County of Fairfax, Virginia

Re: Interpretation for RZ/FDP 2001-MV-018 (Lyndam Hill I) and RZ/FDP 2003-MV-060 (Lyndam Hill II), Tax Map Sheets 108-1 ((17)) A-1 and 108-1 ((1)) 12, 13, 14, 15, and 16 and 108-1 ((3)) 1, 2, and 2A: Clearing and Grading, Tot Lot Relocation, Trail

RE: Lyndam Hill Phase I & II
Plan #'s RZ 2001-MV-018 (Ph. I) & RZ 2003-MV-060 (Ph. II)
VIKA #V6460H

EXHIBIT B

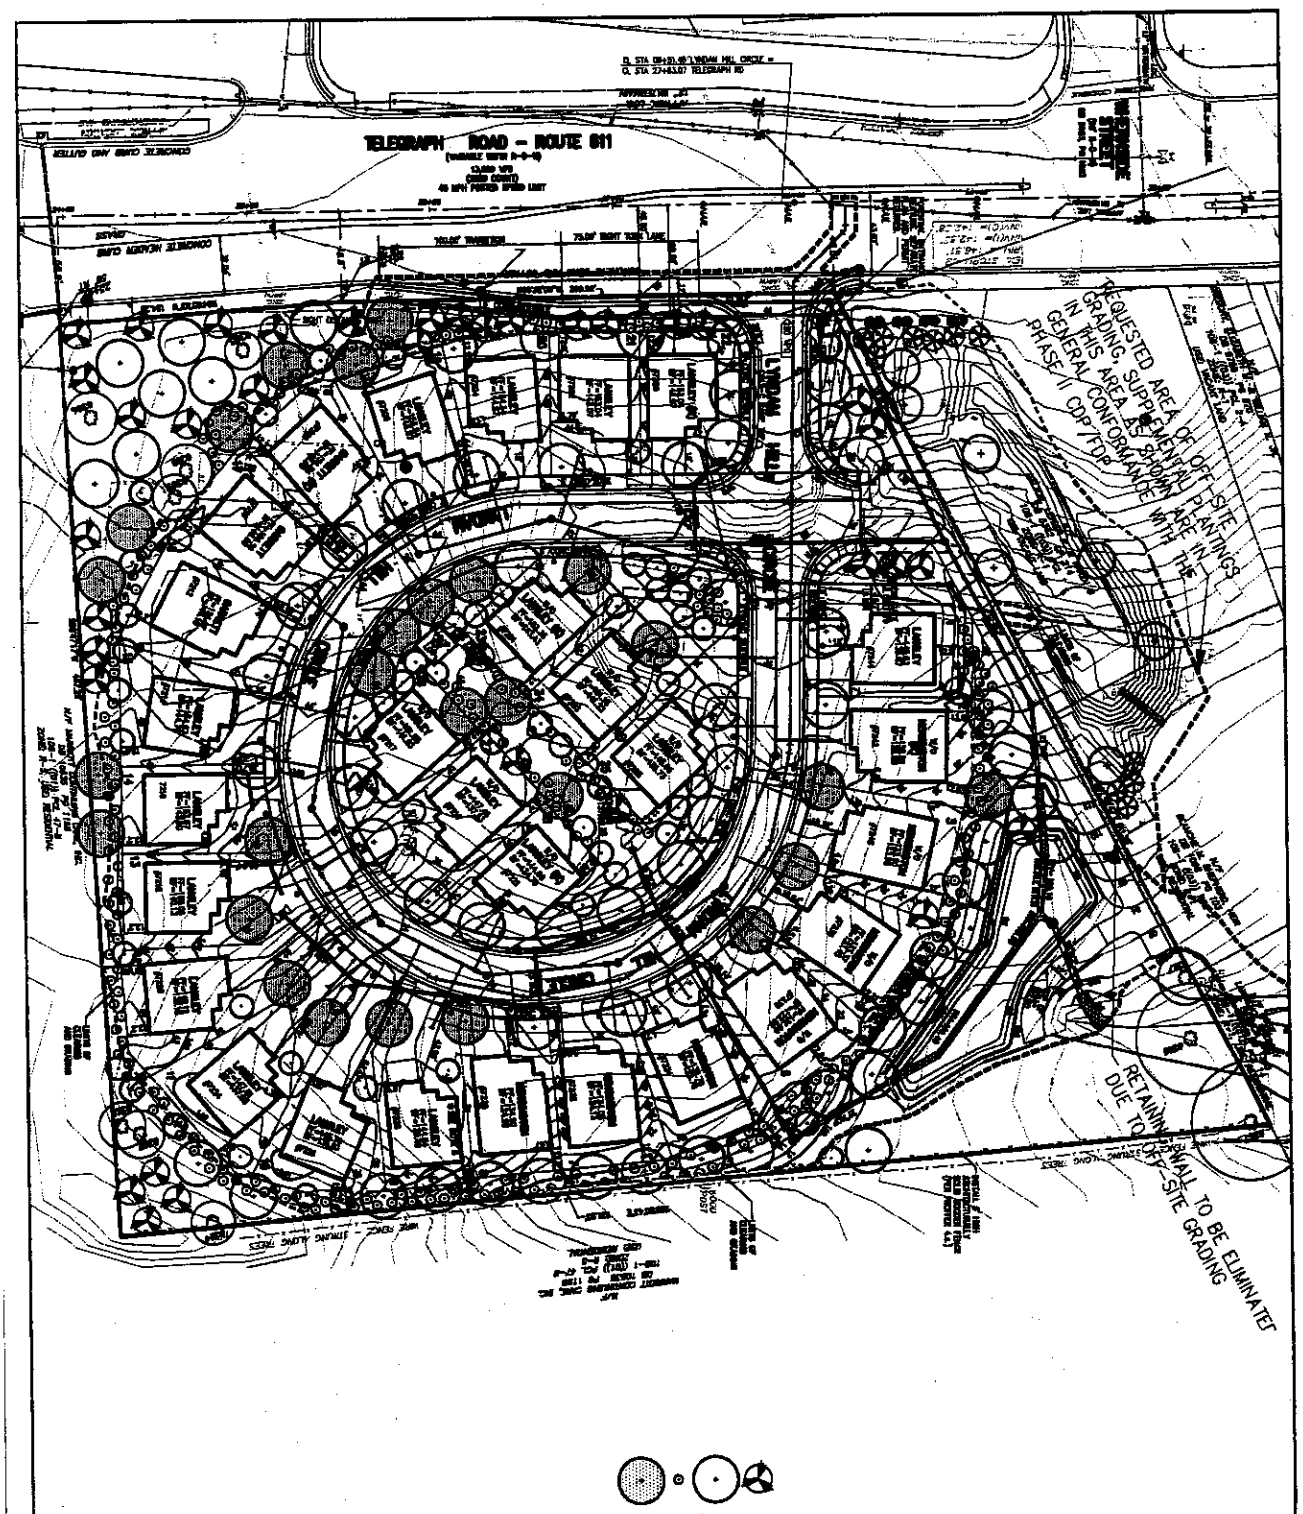
The first question is whether additional clearing and grading along the southeastern side of Lyndham Hill Phase II in order to improve access to the stormwater management (SWM) pond area on Lyndham Hill Phase I, and a shift in location of the pond access road between the two developments, would be in substantial conformance with the proffers, the CDP/FDP, and the development conditions. The CDP/FDP for Phase II designates the current SWM pond access road to be removed and shows a new location for the access road adjacent to Lot 26. However, you have stated that there is a grade difference between the two phases due to excess soil left over from the construction of Phase I that results in the need for a retaining wall between the two developments. You propose to shift soil from Phase I to Phase II and grade the area in the southwestern corner of Phase II to equalize the grades. With the grades equalized, there would be no need for the retaining wall. Further, as I understand, construction of the retaining wall would prevent access from Phase II to the SWM pond via the new access road. Your exhibit shows the new access road shifted toward the west and further from Lot 26 of Phase II. You propose to provide supplemental plantings between the access road and the lot for screening purposes. The limits of clearing and grading for both the Phase I and the Phase II developments permit clearing and grading to the property line in this area of the site; therefore, the proposed grading would be consistent with that shown on the approved development plans. You also state that the additional grading will not require the removal of any trees along the west side of the property line and that plantings that are in general conformance with the plantings shown on the Phase II CDP/FDP will be provided in the graded area. I note that these plantings are shown on your highlighted exhibits. As such, it is my determination that the proposed additional grading and shift in the pond access road located in Phase II discussed above would be in substantial conformance with the proffers, the CDP/FDP, and the development conditions associated with RZ 2001-MV-060, and the proffers and the CDP/FDP associated with RZ 2001-MV-018, provided that a landscape plan including an equivalent number and species of trees to that shown on the CDP/FDP for the graded area is submitted and approved by Urban Forest Management (UFM).

This determination request for Lyndam Hill Phase I involves improving the pond area and reducing maintenance by grading on the adjoining lot (Phase II) to avoid construction of a retaining wall. The property owner of the adjoining property is also Horton Building, who built Phase I and is also

holding the bond. They are requesting that you allow this grading on their property to allow for better coordination between Phases I and II of this development. Horton Building has also prepared and submitted a site plan (FFX. Co. #7080-SP-01) for the adjoining property that further demonstrates that the retaining wall in this area is not required or appropriate. We have included a copy of the Lyndam Hill Phase II site plan (Exhibit D) that was submitted to Fairfax County for your review. The additional grading will not require the removal of any trees along the west side of the property line and is in conformance with the Limits of Disturbance on the approved Phase II CDP/FDP. Additionally, we have provided supplemental plantings that are in general conformance with the ultimate plantings shown on the Phase II CDP/FDP. It is our intent, if this interpretation is approved, to submit a formal revision to the Phase I approved Site Plan.

EXHIBIT D

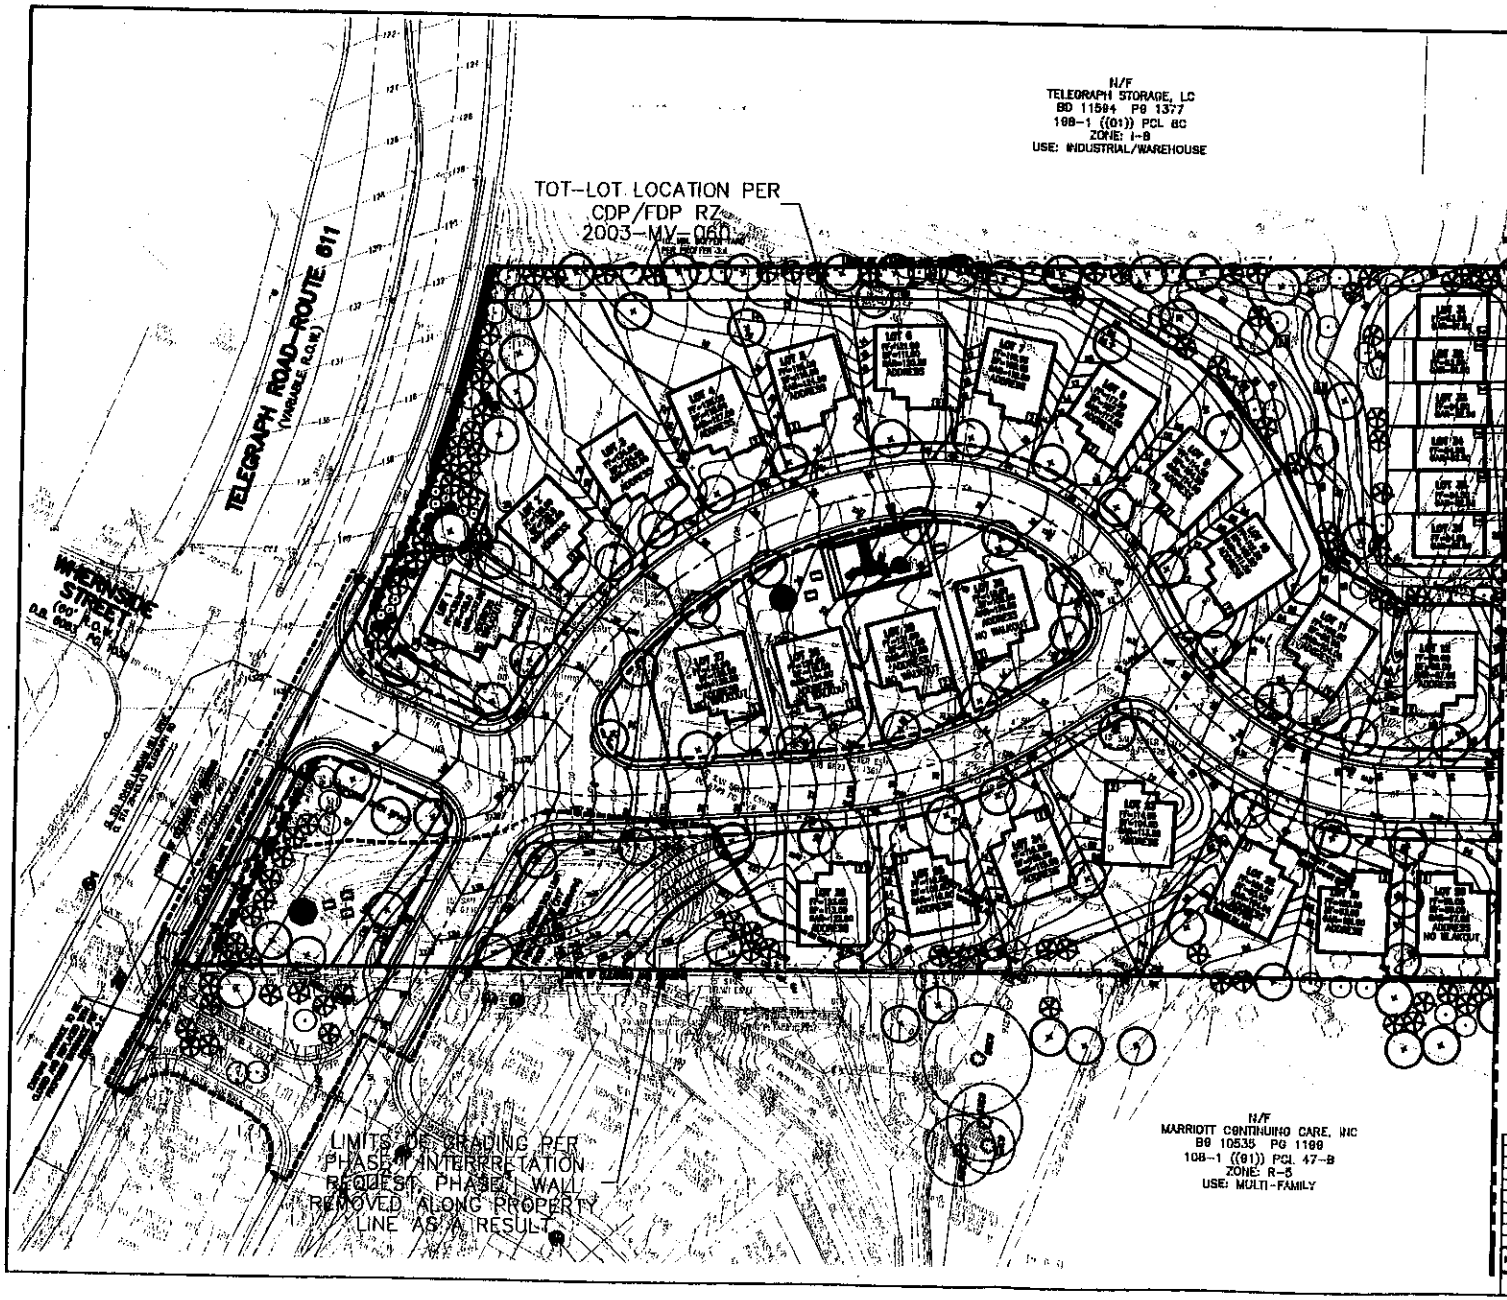
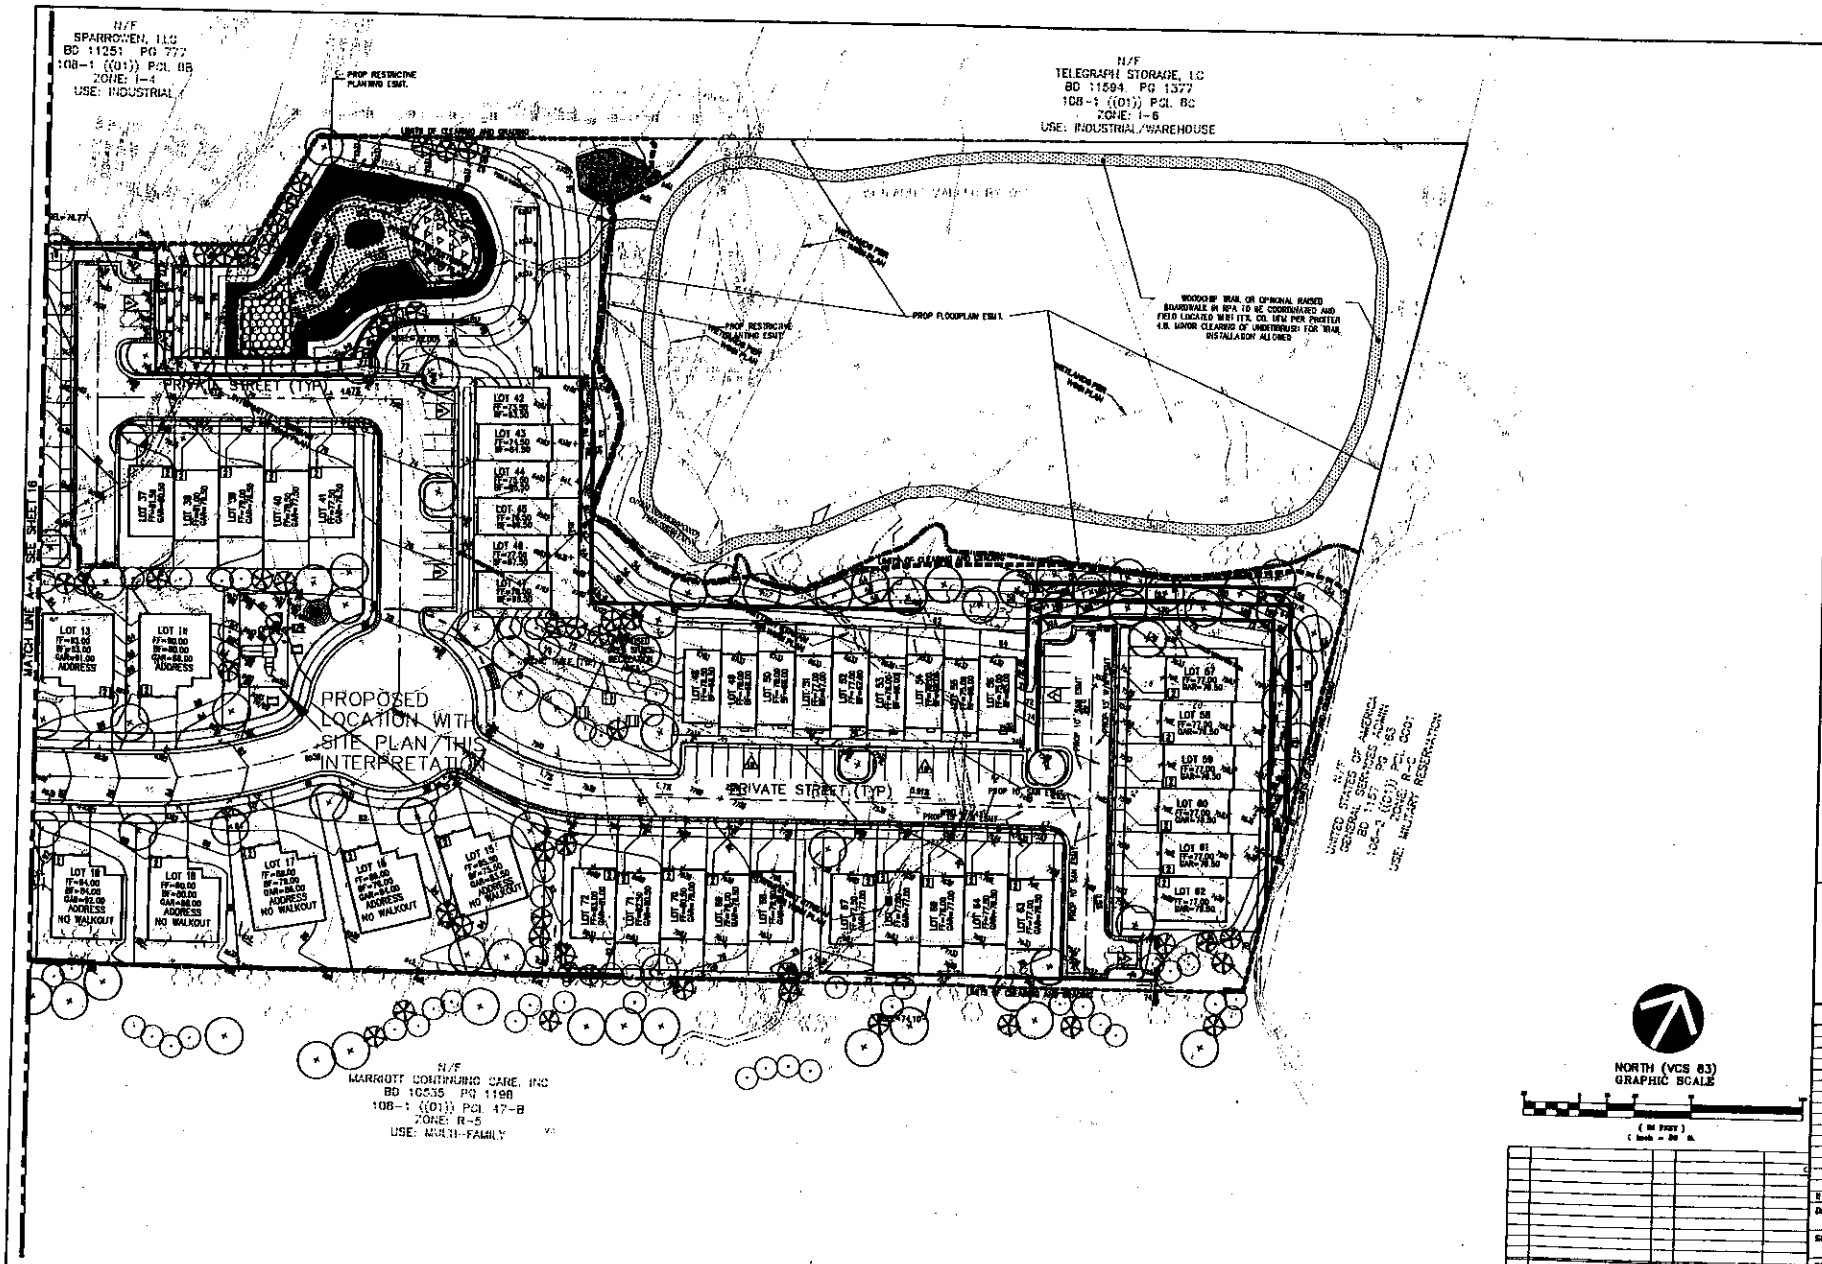
The second question is whether the proposed relocation of the tot lot in Lyndham Hill Phase II would be in substantial conformance with the proffers, the CDP/FDP, and the development conditions. The approved CDP/FDP for Lyndam Hill Phase II depicts a tot lot located in the west central part of the development adjacent to Lot 29. You propose to relocate the tot lot toward the east adjacent to the cul-de-sac. You state that the tot lot/playground will contain all of the elements shown on the CDP/FDP and specified in Proffer 4.d., which states that *"The Applicant*

shall provide playground equipment in accordance with PFM standards and consistent with the typical tot lot shown in the Community Recreation Area Layout on Sheet 5 of the CDP/FDP. Playground equipment shall include, at a minimum, one (1) slide, a climbing apparatus, two (2) riders and two (2) swings." The proposed tot lot design is provided on Exhibit D of your submission. According to your letter, the proposed location will be more centrally located and will not affect the drainage of any of the units. You state that the area will be walled on three sides with a 4 foot high wall as in the original location. It is my determination that the proposed relocation of the tot lot as shown in your exhibits would be in substantial conformance with the proffers, the CDP/FDP, and the development conditions.

The third question is whether the construction of a raised boardwalk instead of a woodchip trail in the Resource Protection Area (RPA) located in Lyndam Hill Phase II would be in substantial conformance with the proffers, the CDP/FDP, and the development conditions. You state that the proposal to construct a raised boardwalk instead of the woodchip trail is based on a request from the wetland consultant for the project who has said that the State and Federal agencies that will review the wetland application consider woodchip trails as fill with permanent impacts on the wetland. A letter from Wetland Studies and Solutions was received in this office on January 18, 2012, stating that a boardwalk-type trail in a forested wetland is considered a temporary impact and is the preferable type trail in the wetlands portion of the RPA on the site. You are asking if the raised boardwalk-type trail would be in substantial conformance with the approved zoning in the event that the State and Federal agencies recommend it. You state that you would like to preserve the option to construct the woodchip trail in the event that the raised boardwalk is not recommended. You state that the location of the trail would not change from that shown on the CDP/FDP and that its construction would conform with Proffer 3.d. which reads as follows:

The Tot Lot/Playground and woodchip trail are part of a larger development known as Lyndam Hill Phase II as shown on the approved CDP/FDP. The plans for this development are currently in the design and review phase and nothing has been constructed to date on this property. The Applicant proposes a minor modification to the location of the Tot Lot/Playground from that shown on the approved CDP/FDP as well as a request to reserve the option to convert the woodchip trail into a raised boardwalk, these changes would be in accordance with the attached sketch prepared by VIKA, Inc. dated September 22, 2011 (Exhibit D). I have also enclosed a copy of Sheet 3 of the CDP/FDP (Exhibit C) and the proffers for comparison. The Tot Lot/Playground will contain all elements shown on the CDP/FDP and associated proffer 4.d. The Tot/Lot/ Playground proposes a wall on three (3) sides just as the previous location did, the wall height at its highest point is 4'+/- in the southwest corner and then quickly decreasing as the proposed grades in this area are sloped at 3:1 along the wall. The proposed location works better from a design/layout standpoint because the proposed location does not affect the drainage of any units and is centrally located for all future residents of the development.

The request to reserve the right to convert the woodchip trail into a raised boardwalk is based on a request from the wetland consultant for this project as State and Federal agencies that will be reviewing the wetland application consider woodchip trails as fill and thus, the jurisdictional wetlands and streams where the trail is located would be considered as having permanent impacts. Raised boardwalk trails are considered temporary impacts by the agencies and are a preferred method of constructing a trail through forested wetlands and over streams. This request isn't to remove the option for a woodchip trail but to merely give the option to provide a raised boardwalk in the event the State and Federal agencies that will be reviewing our application deem this the best approach. As such, this request would still conform with proffer 3.d. and merely provide an

As such, it is my determination that the construction of a wooden boardwalk in lieu of a woodchip trail in the RPA, as discussed above, would be in substantial conformance with the proffers, the CDP/FDP, and the development conditions, subject to DPWES review and approval.
